## PUBLIC UTILITIES COMMISSION

**RE: Deficiency Report #4 - Certificate of Public Convenience and Necessity for the  
Riverside Transmission Reliability Project – Application No. A.15-04-013**

# DEFICIENCY REPORT #4 FOR THE RIVERSIDE TRANSMISSION RELIABILITY PROJECT APPLICATION (A. 15-04-013)

**CPUC Riverside  
Work Area Constraints  
Mapbook**

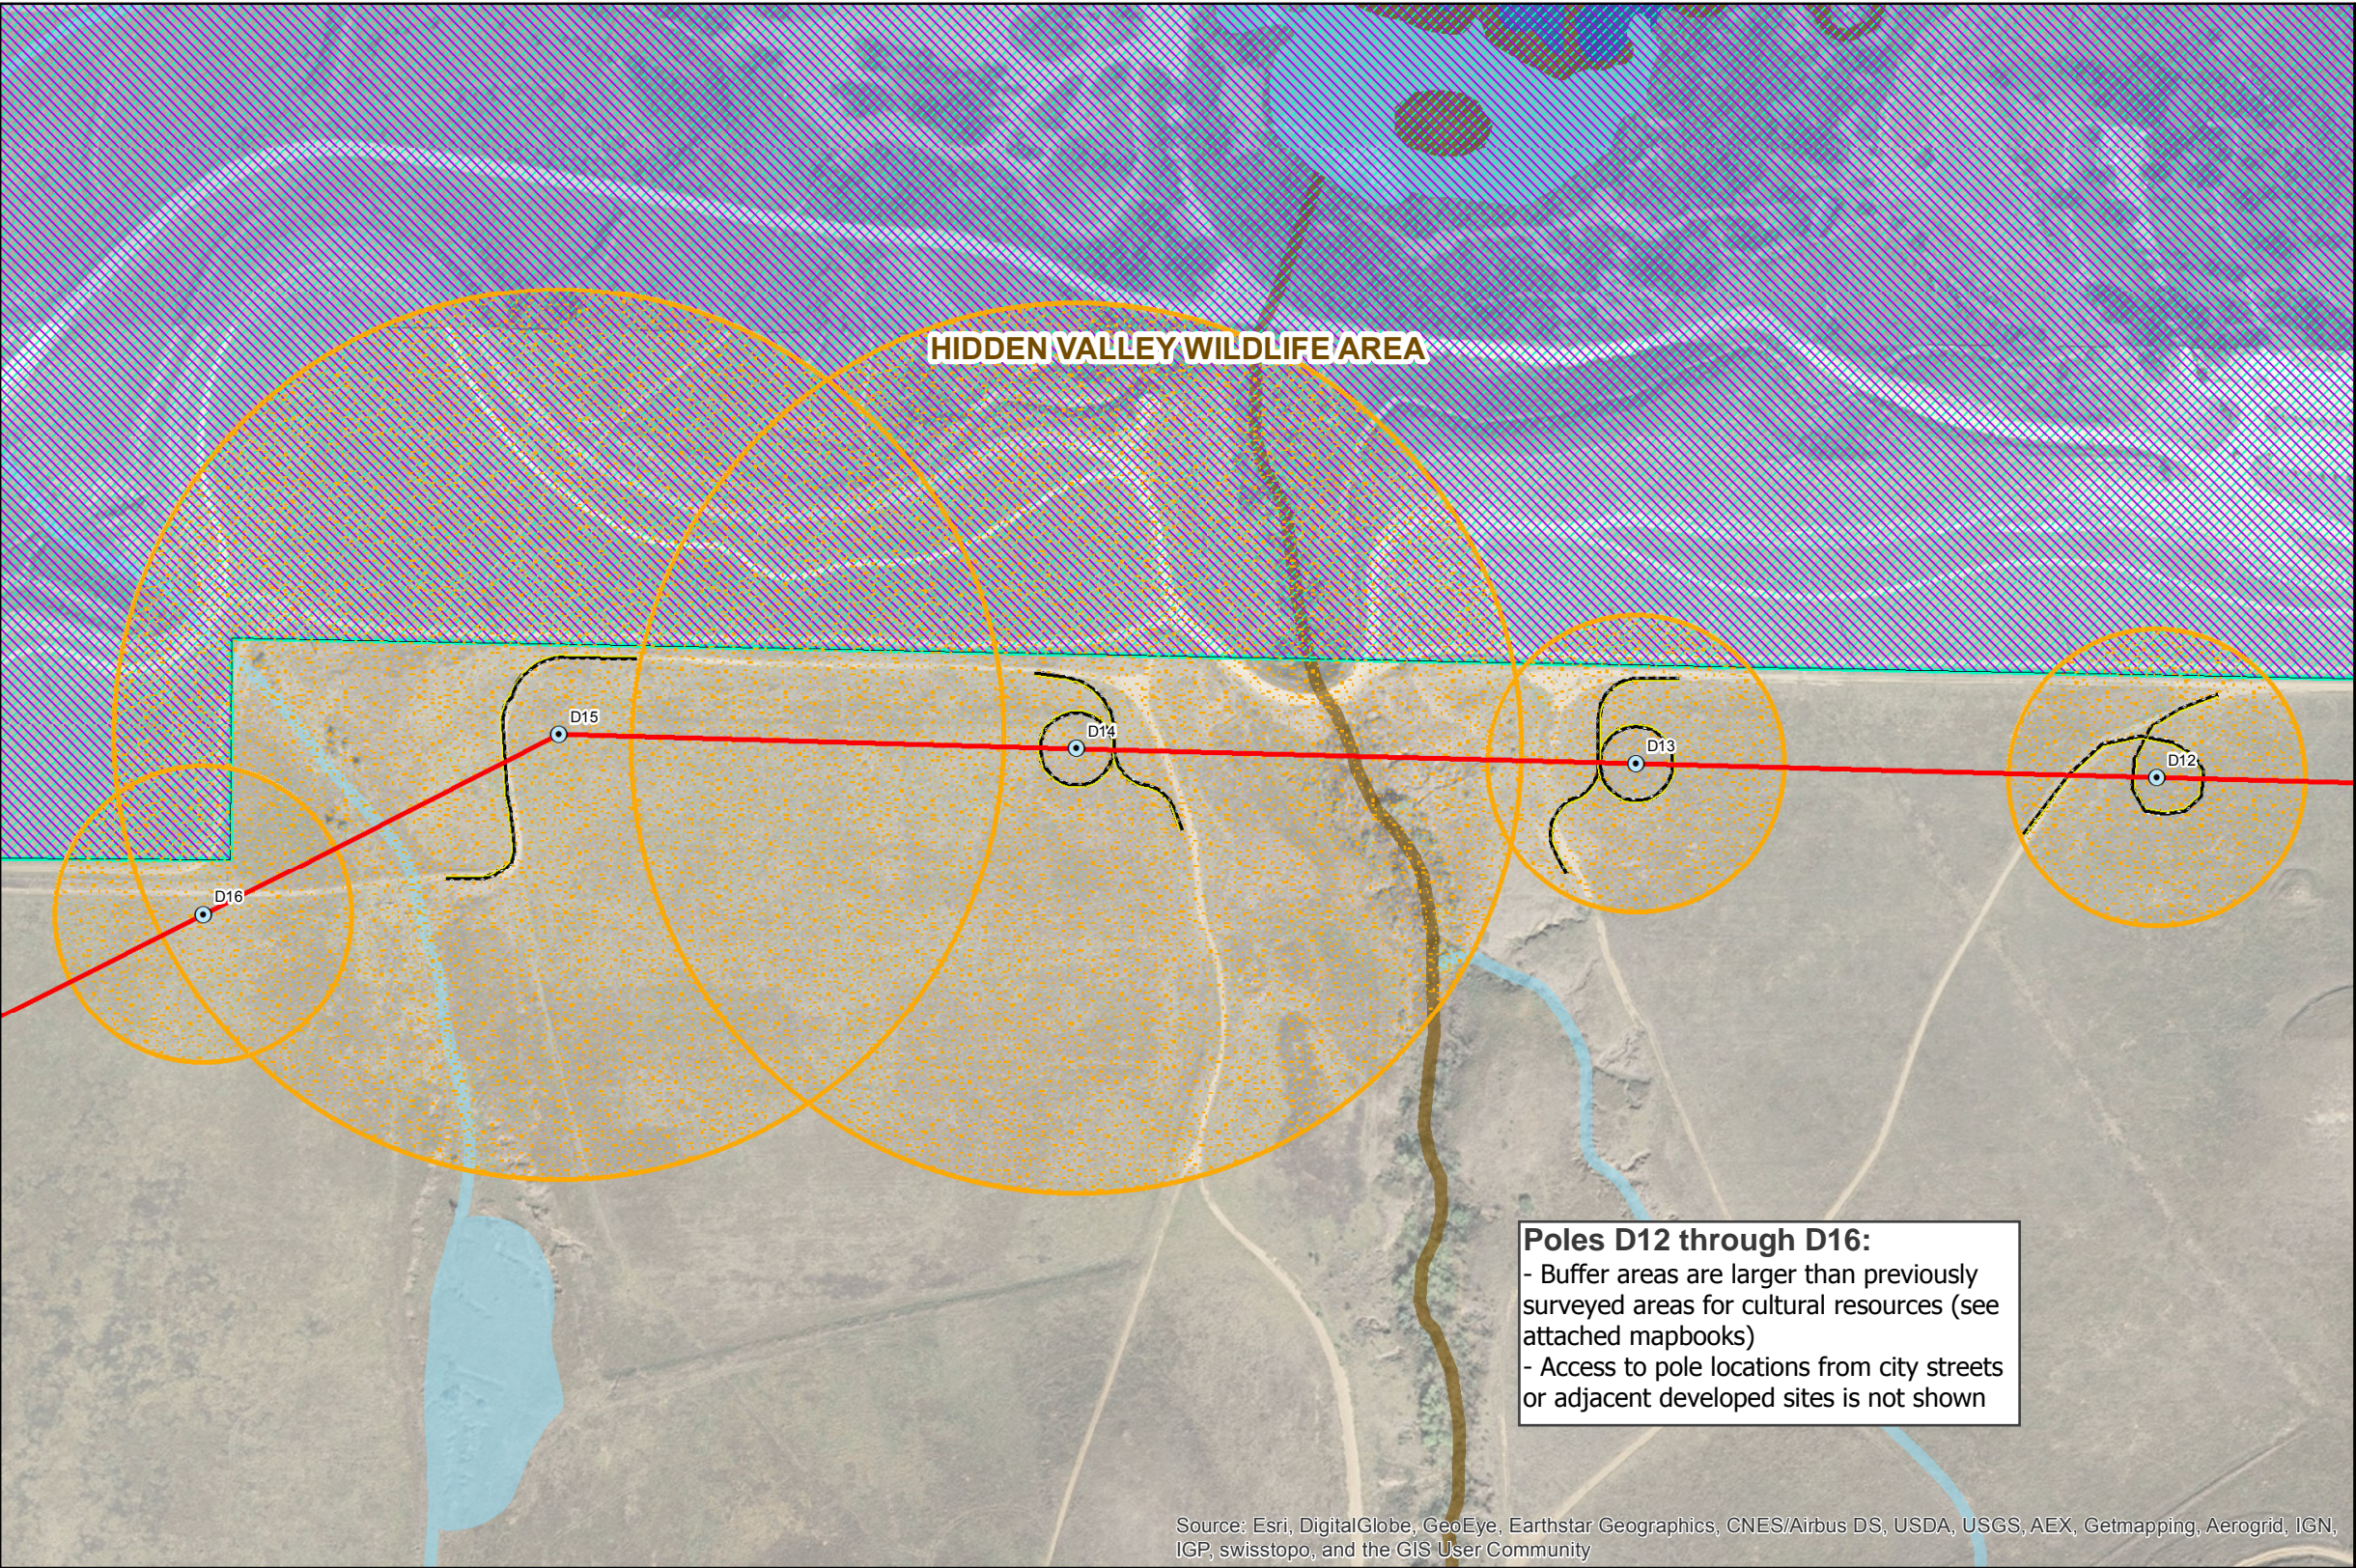
**Poles D10 and D11:**

- Buffer areas are larger than previously surveyed areas for cultural resources (see attached mapbooks)
- Access to pole locations from city streets or adjacent developed sites is not shown

**Poles D8 and D9:**

- Access to pole locations from city streets or adjacent developed sites is not shown

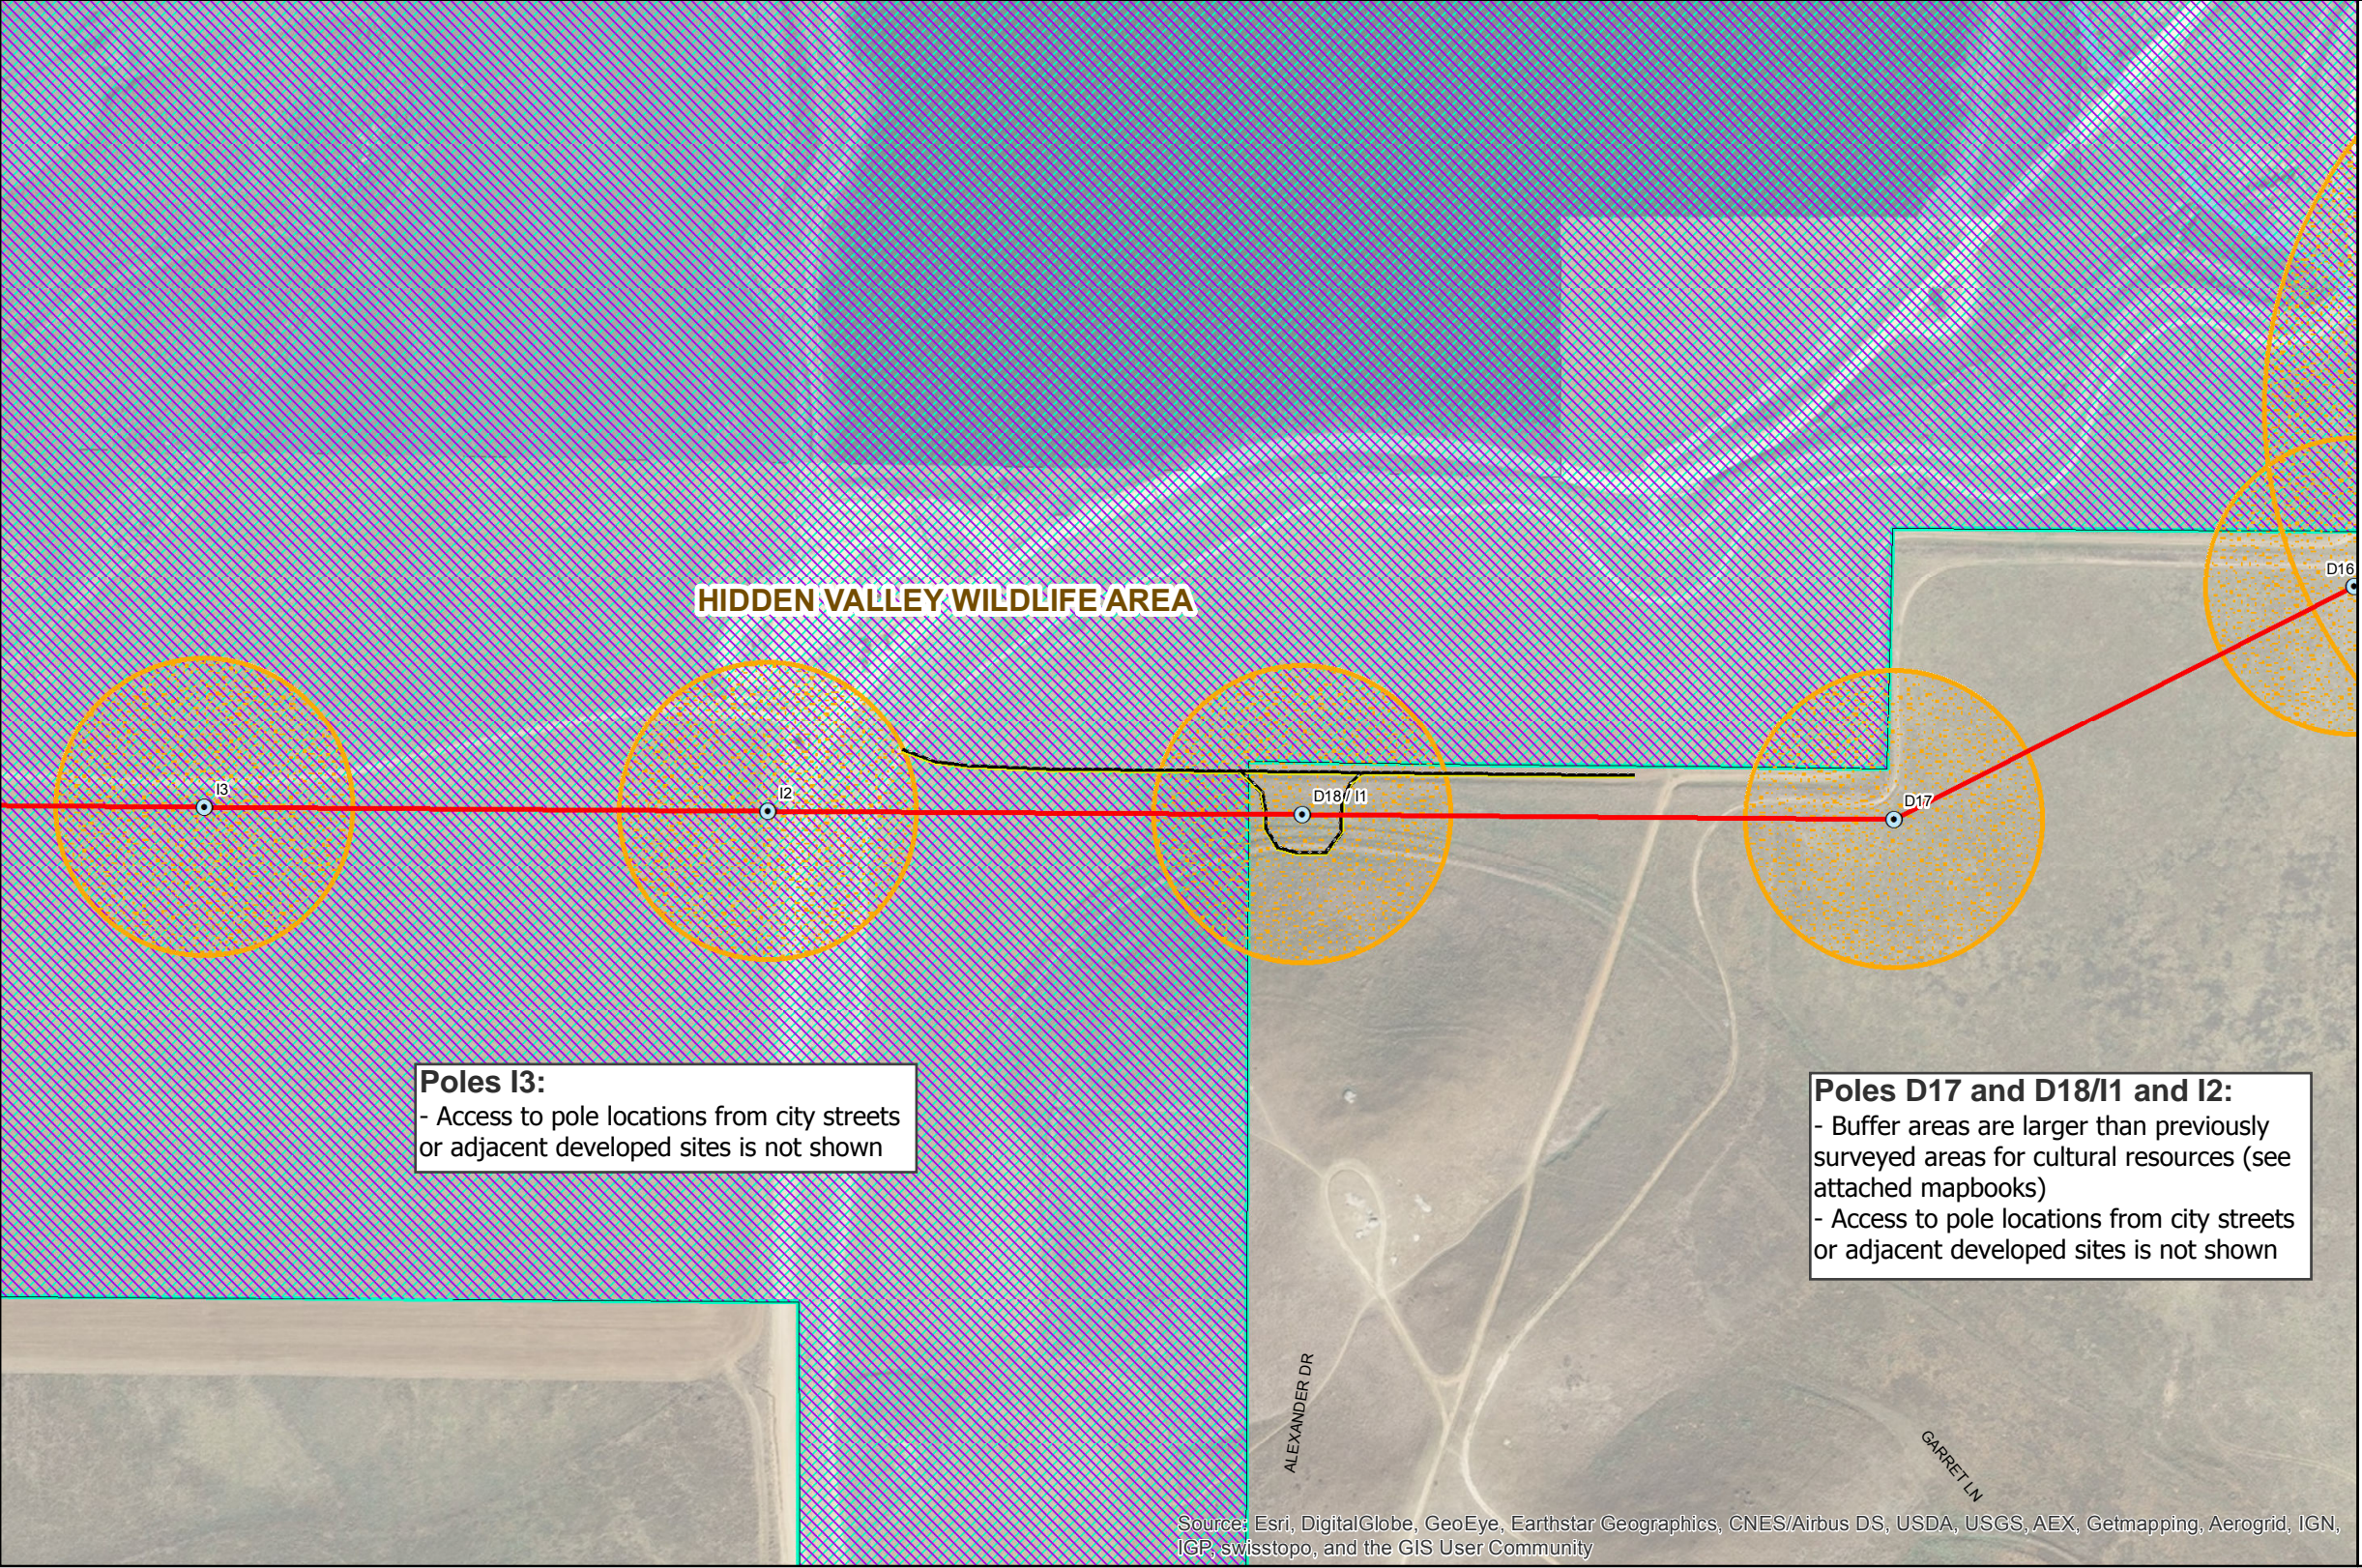
**Poles D12 through D16:**

- Buffer areas are larger than previously surveyed areas for cultural resources (see attached mapbooks)
- Access to pole locations from city streets or adjacent developed sites is not shown

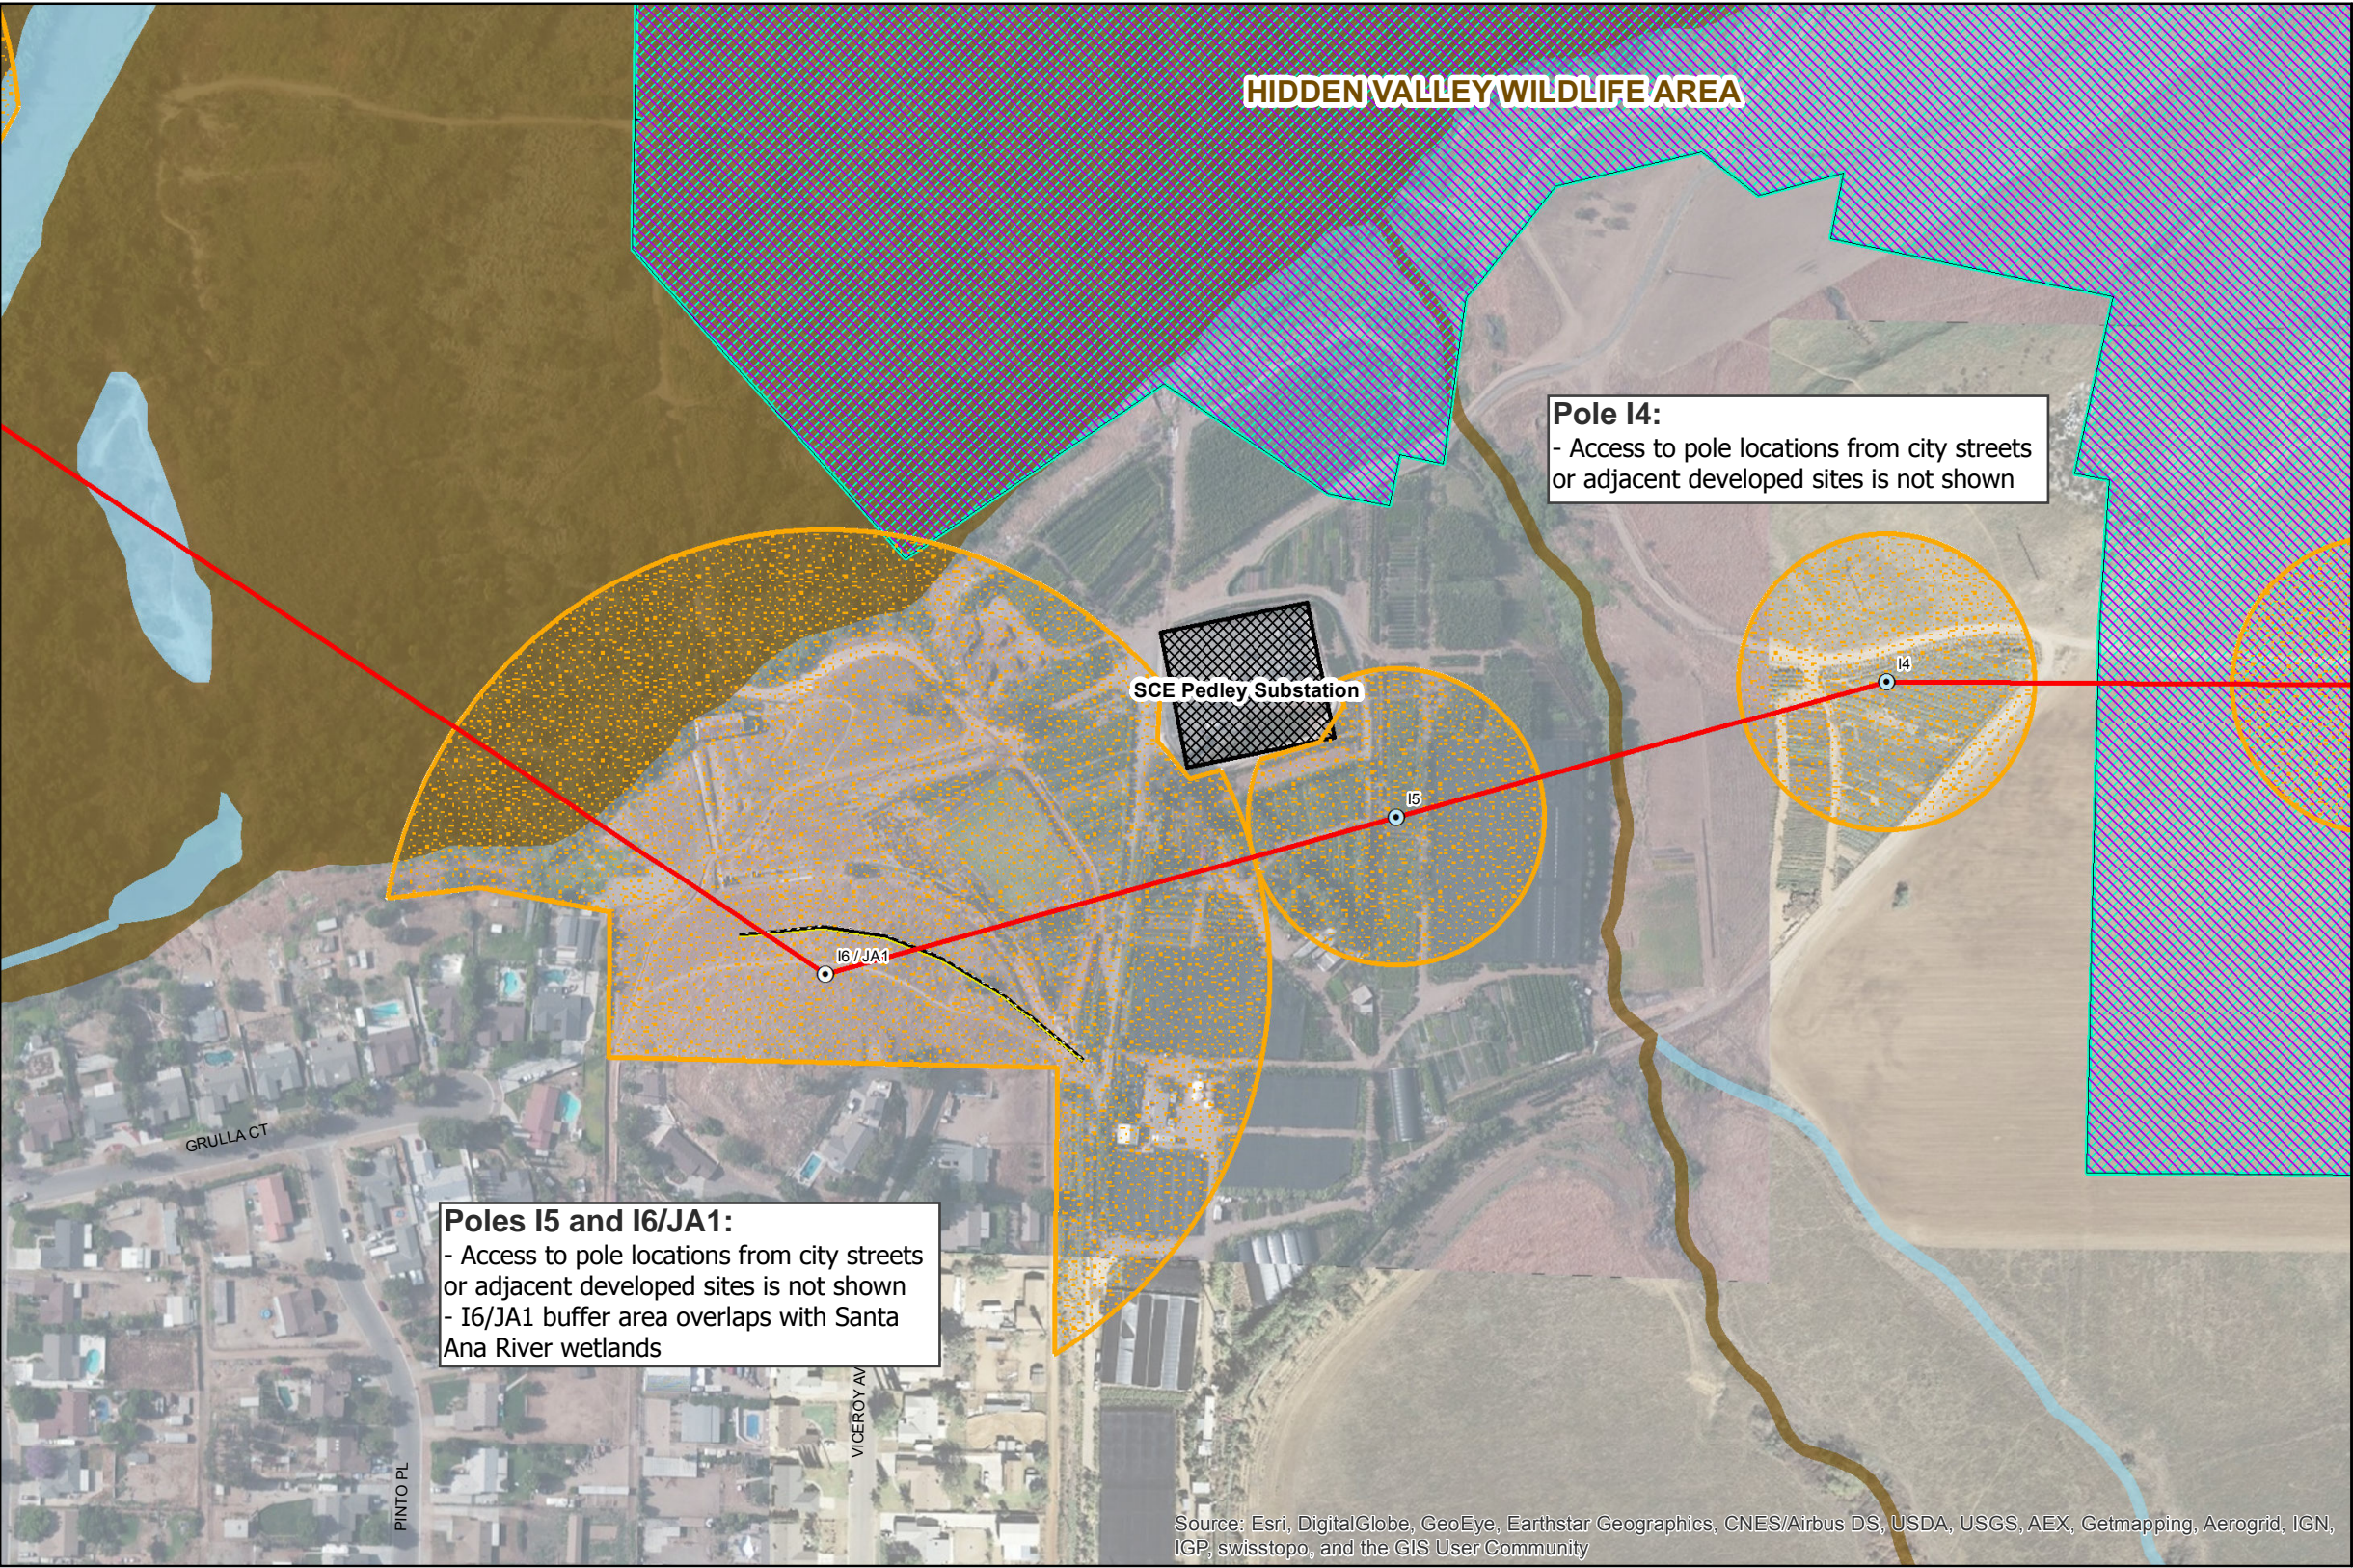
**Poles I3:**  
- Access to pole locations from city streets or adjacent developed sites is not shown

**Poles D17 and D18/I1 and I2:**  
- Buffer areas are larger than previously surveyed areas for cultural resources (see attached mapbooks)  
- Access to pole locations from city streets or adjacent developed sites is not shown
